Access Compliance Report Public Rights-of-Way (Curb Ramps)

Main Street: **SPRING_ST** Cross Street: **N/A** Location: **NW**

ADA ID: **RPRK211223123956** Ramp Type: **Type 4 - Parallel** Initial Pass/Fail: **Pass** Overall Compliance: **No** Severity Score: **0**

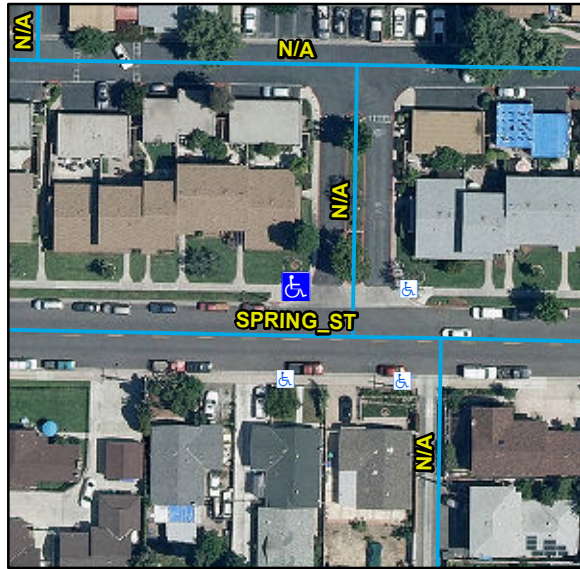
R204.3, STD 1115

Remove & Replace Curb Ramp With Two New Directional Ramps or Equivalent.
